Change Order Request

#0348- Rineyville Elementary School
275 Rineyville School Rd
Rineyville, KY 40162

Change Order Request: 078

Description	Category	Status
Add 6 laminate tables	Change Order	In Review

COMPUTER ROOM TABLE BASES

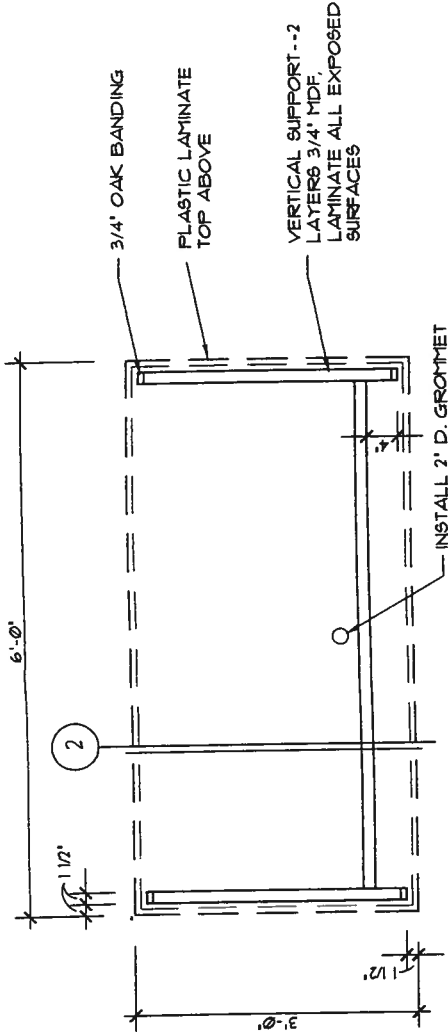
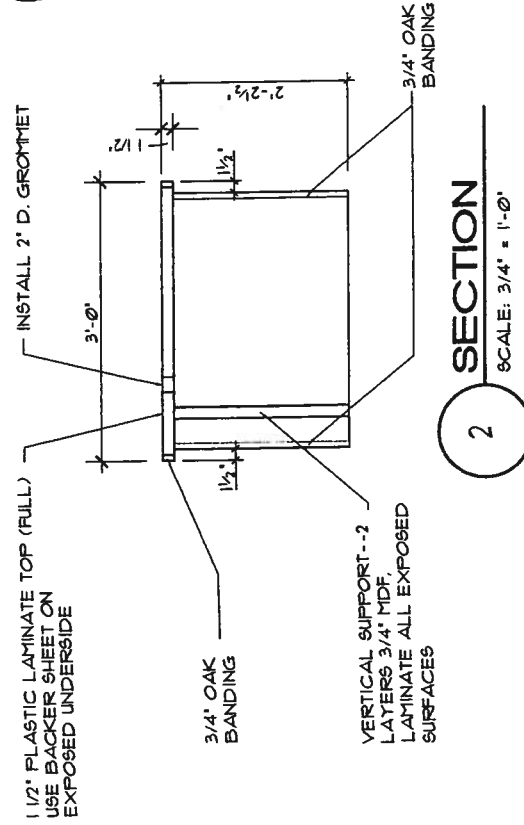
BASE OF TABLES IN
COMPUTER ROOM 247
